Ref 23/00452/FUL

Planning Consultation Response

Proposed construction of apartment block consisting of 12 units with associated landscaping and parking facilities at Vacant Land The Ridgeway Runcorn Cheshire

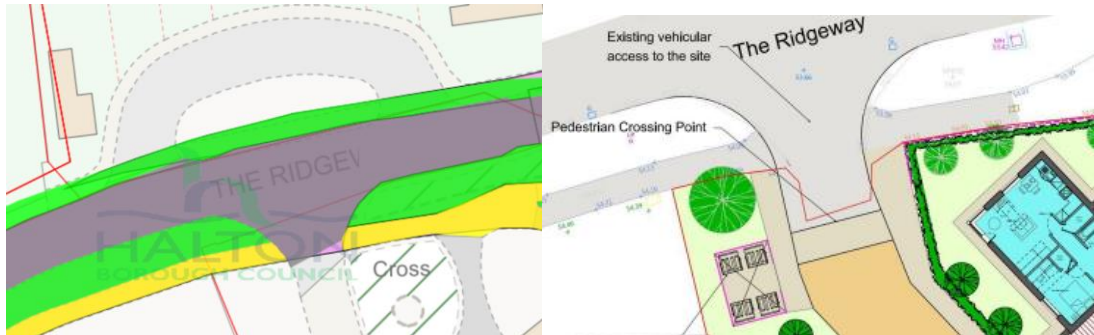
The footpath behind the parking spaces is deemed superfluous and a third space could be accommodated in the aisle of two with the row of 4 moving back in line with the last space.

Separating two spaces about the access is considered more appropriate for ped access than a boundary footpath to the parked cars.

As can be seen in the snippets above the pedestrian crossing facility lies within the access to the private parking, crossing facilities should be offered within the adopted highway.
